Docket Number:	16-AAER-02
Project Title:	Appliance Efficiency Rulemaking for Computers, Computer Monitors, and Signage Displays
TN #:	213957
Document Title:	Presentation - NRDC's Comments on CEC's Proposed Computer Energy Efficiency Standards by Pierre Delforge
Description:	NRDC's Comments on Computers - CEC workshop - Oct. 10, 2016
Filer:	Harinder Singh
Organization:	Natural Resources Defense Council (NRDC)
Submitter Role:	Public
Submission Date:	10/11/2016 9:07:54 AM
Docketed Date:	10/11/2016

NRDC's Comments on CEC's Proposed Computer Energy Efficiency Standards

Pierre Delforge
Natural Resources Defense Council

Computers: High-expandability threshold

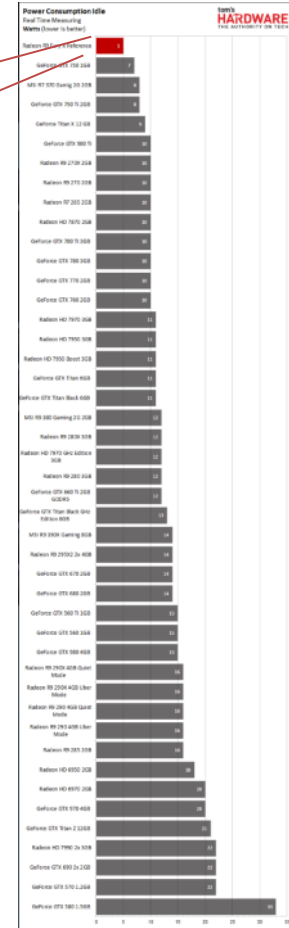
- Radeon R9 Fury X, one of the first cards to use HBM, also has lowest idle power (2015 testing)
- High-bandwidth cards don't need an exemption, graphics adder sufficient
